Application for Variation of an Environmental Permit

Environmental Review Report (ERR) for
Application for Variation to the Environmental
Permit

China Harbour Engineering Company Limited

June 2026

Existing Site Location Plan

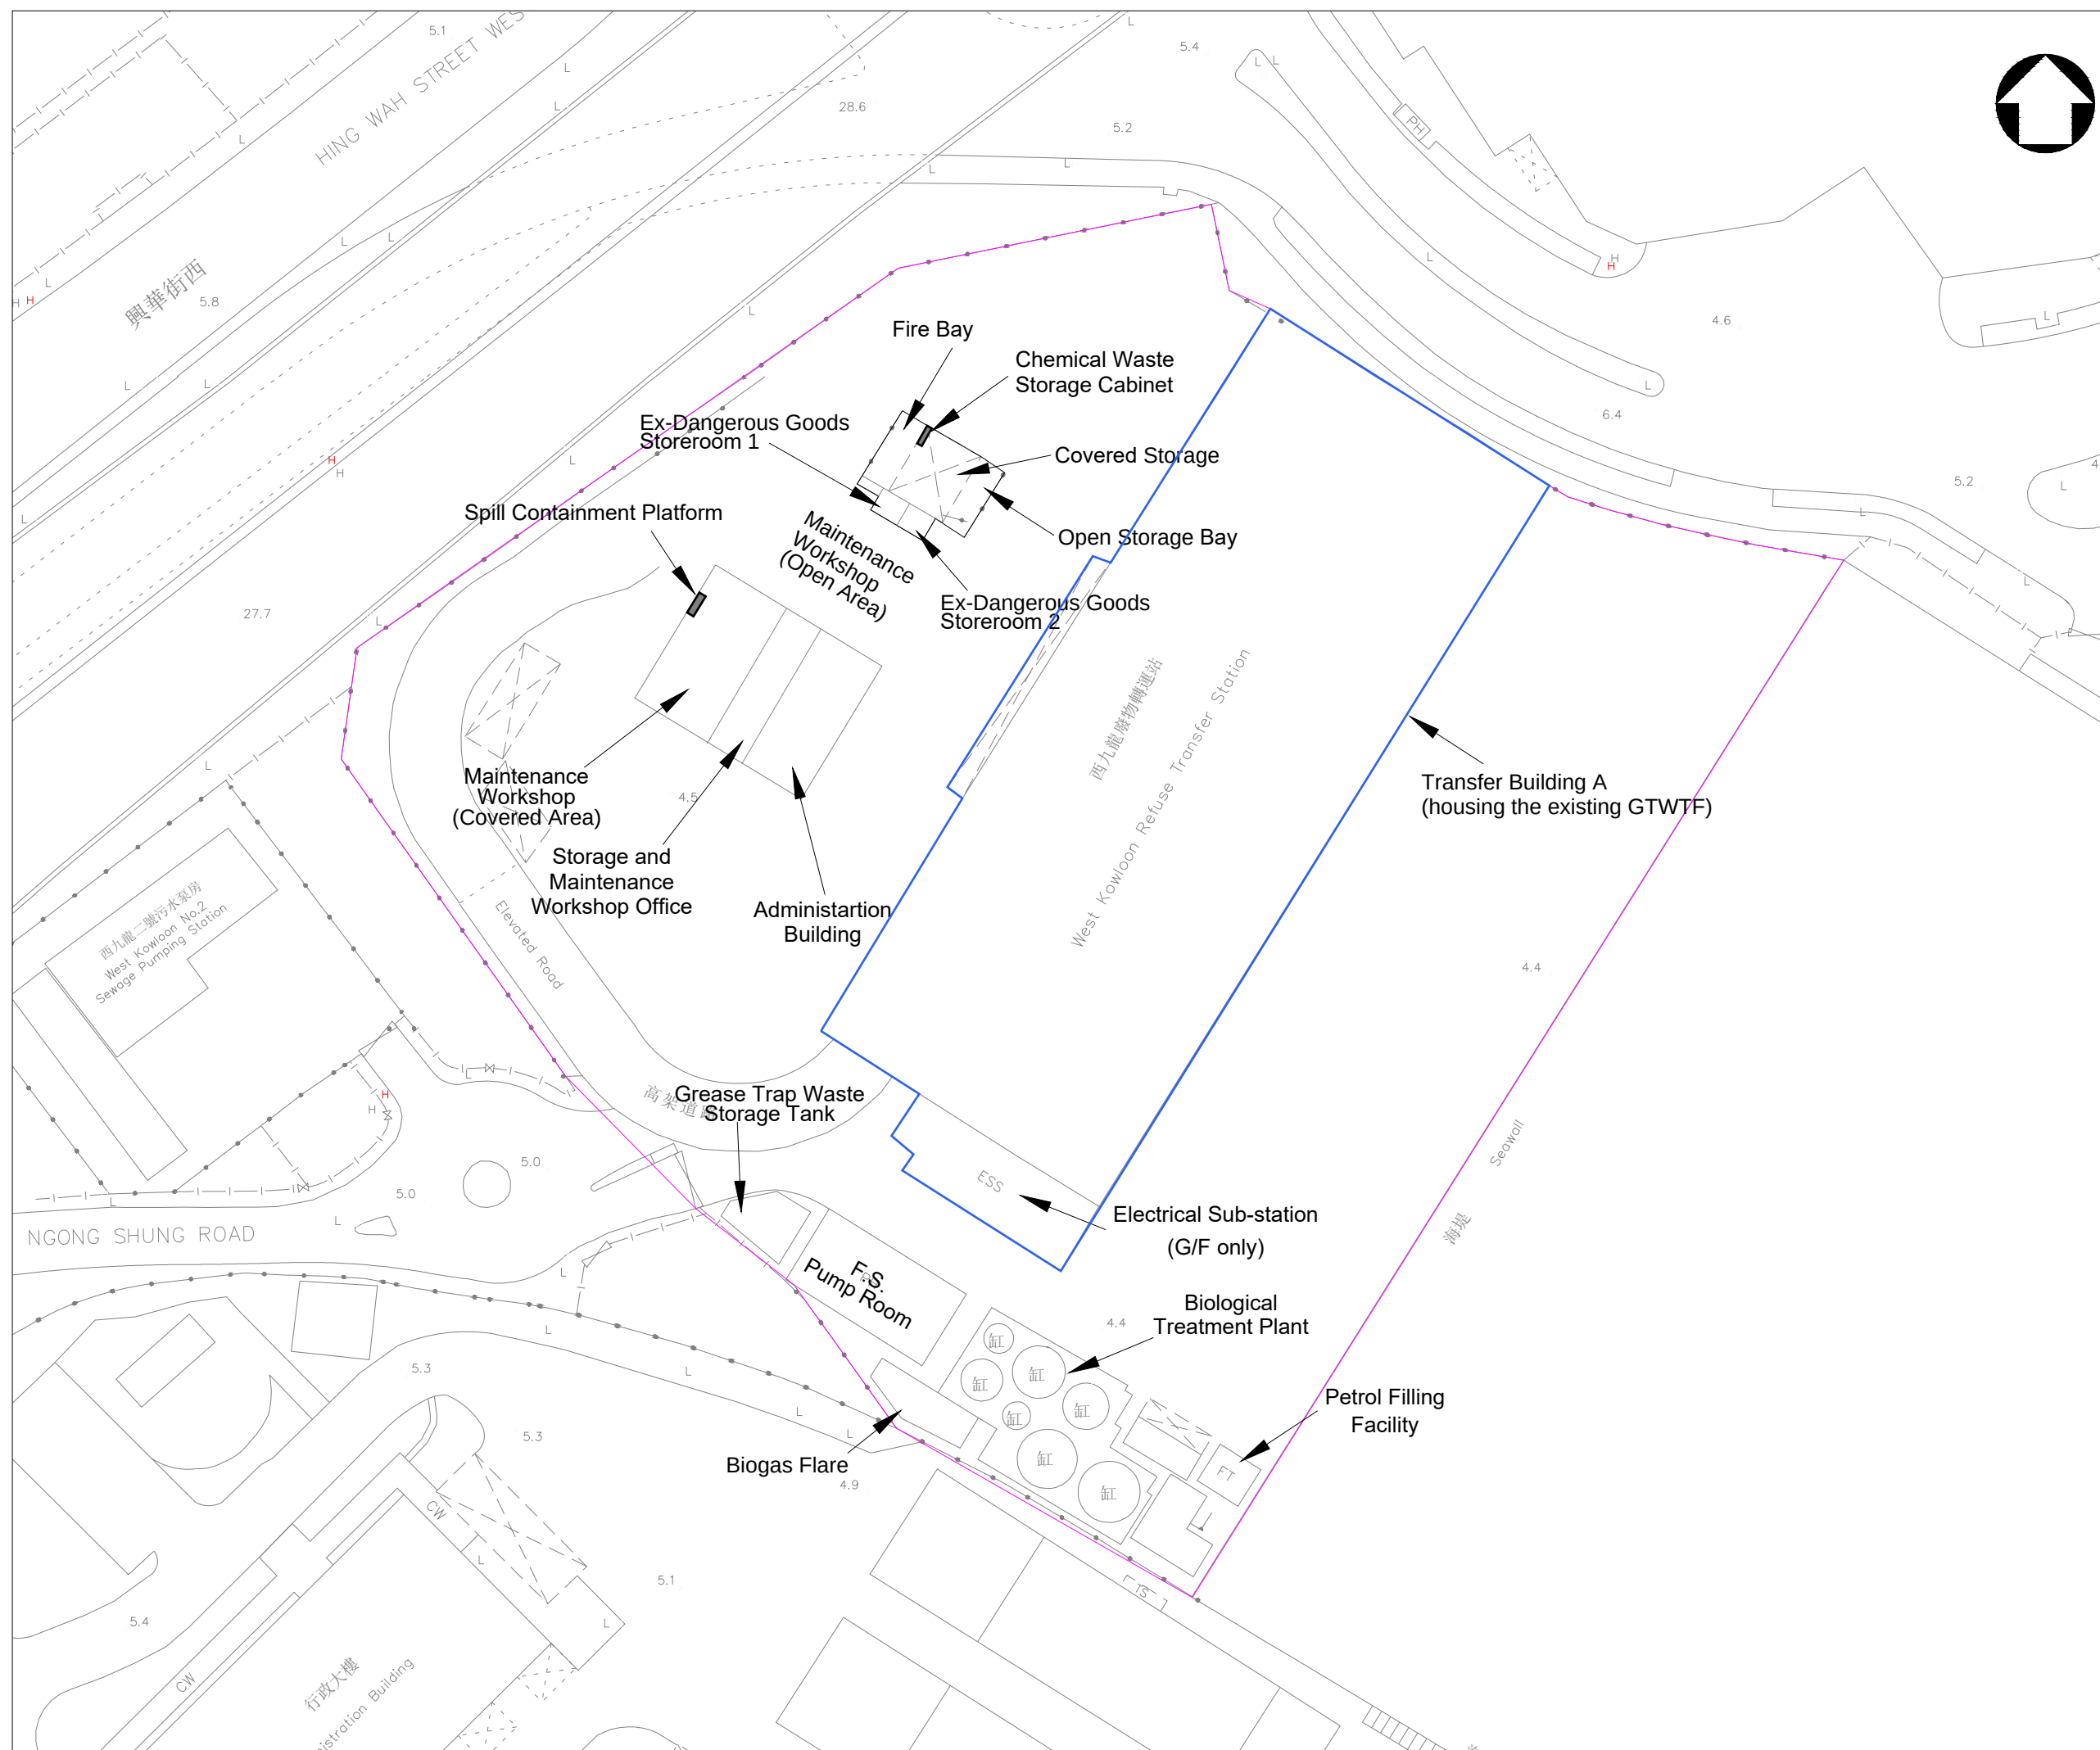
- 1.1.6. Refer to **Figure 1.1** for the existing location plan of the WKTS before the proposed upgrade and **Figure 1.2** for the location plan after the proposed upgrade of the Project.

- 2.1.4. The existing location plan of WKTS including the current GTWTF at TBA is shown in **Figure 1.1**, whilst the location plan after the proposed upgrade with the new TBB is shown in **Figure 1.2**. Refer to **Figure 2.1** for details of the proposed decommissioning and construction works, and **Figure 3.2-3.3** for the existing and proposed air scrubber units. Preliminary floor layout plans of GTWTF are provided in **Appendix A** and the proposed waste collection vehicle traffic routes are shown in **Appendix B**.

Figure 2.2 – Proposed GTWTF Process Flow Diagram

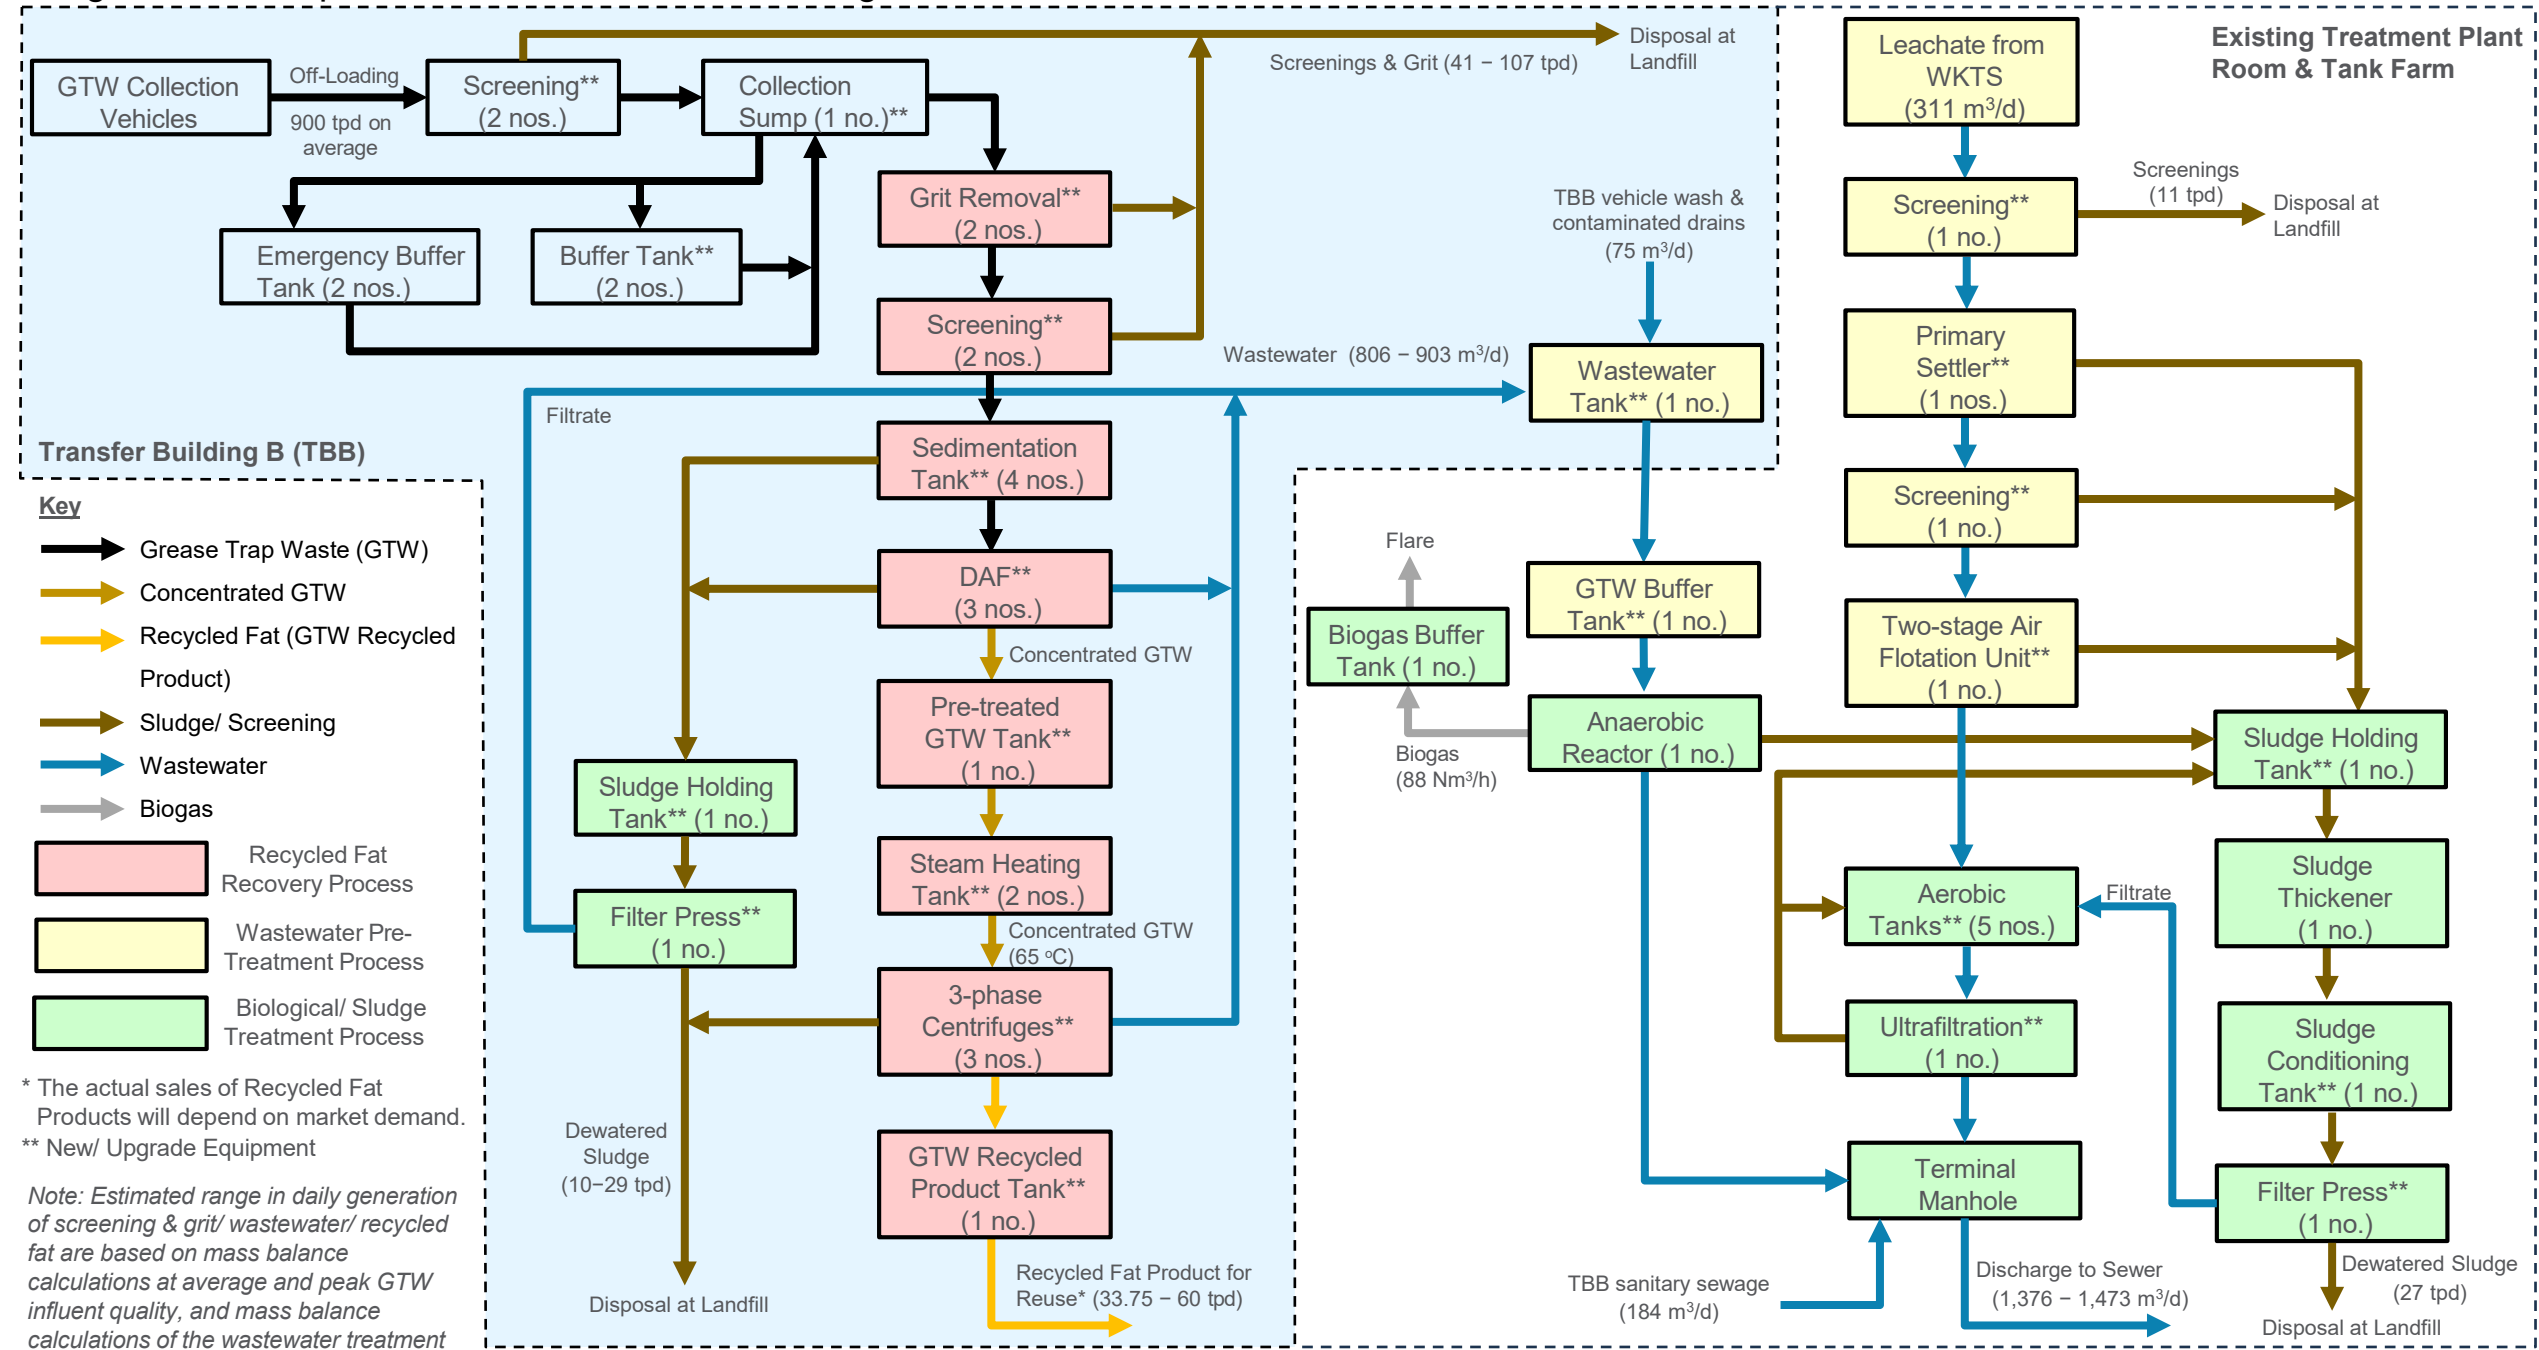
- 2.1.7. **Figure 2.2** shows the proposed Process Flow Diagram (PFD) for the new GTWTF. As shown in the figure, the new quantities / throughput rates are based on a combination of the anticipated improvements due to the proposed equipment re-provision and the recorded operational parameters of the existing GTWTF.

Location of Emission Sources under Existing Scenario

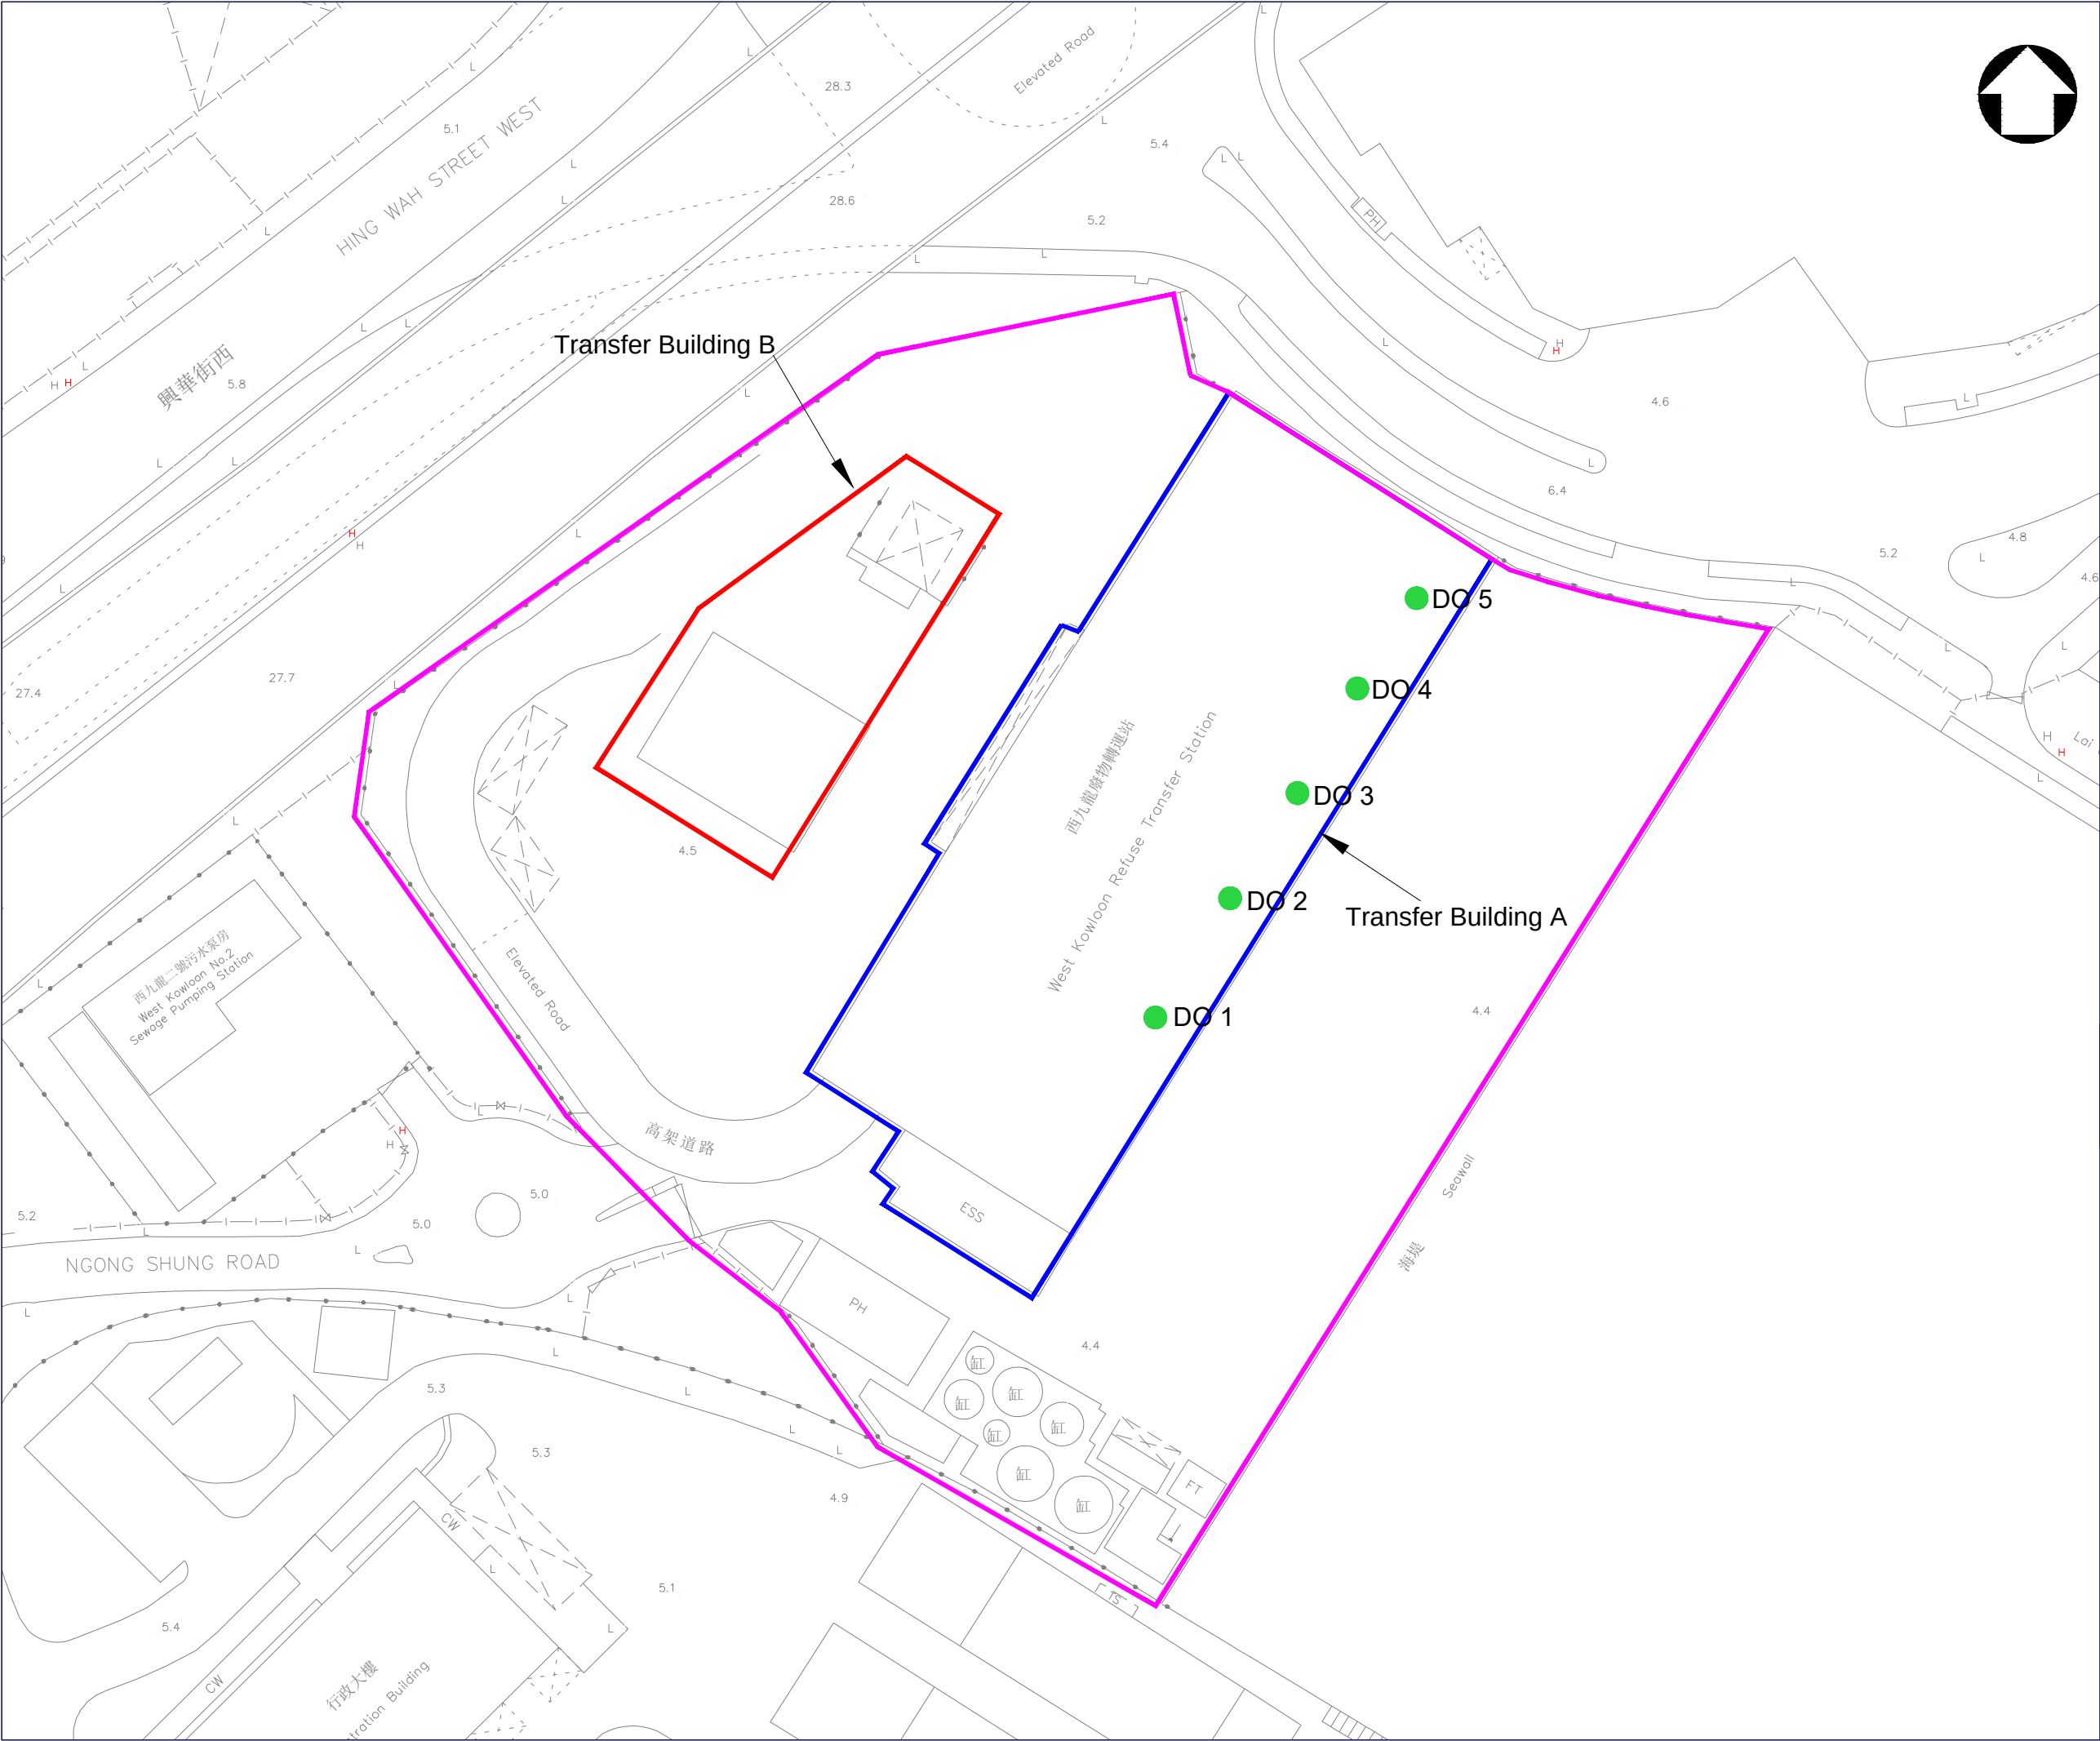
- 3.4.11. Under the Existing Scenario, there are five existing air/odour emission exhausts DO1 to DO5 located at TBA as shown in **Figure 3.2**, whilst there are two additional proposed emission exhausts DO 6 and DO7 in TBB as shown in **Figure 3.3**. Compared to the Existing Scenario, all of the representative ASRs remain the same distance from the closest emission exhausts under the Proposed scenario except for ASR6, for which the closest distance is shortened from 369m to 321m (i.e. due to the proposed exhaust DO6). Nevertheless, the additional exhausts are still more than 320 metres from ASR6. See **Table 3-5** below.

- 3.4.16. As shown in **Table 3-6** below, the existing air scrubbers DO1, DO2, DO4 and DO5 are two-stage wet scrubbers designed to remove 99.9% of Hydrogen Sulphide (H₂S) and 90% of Ammonia (NH₃), unit DO3 is a one-stage unit for removing 99.9% of Hydrogen Sulphide (H₂S), and unit DO5 is a standby unit with two-stage removal of 99.9% H₂S and 90% NH₃. See **Figure 3.2** for the location of the existing air scrubber exhausts.
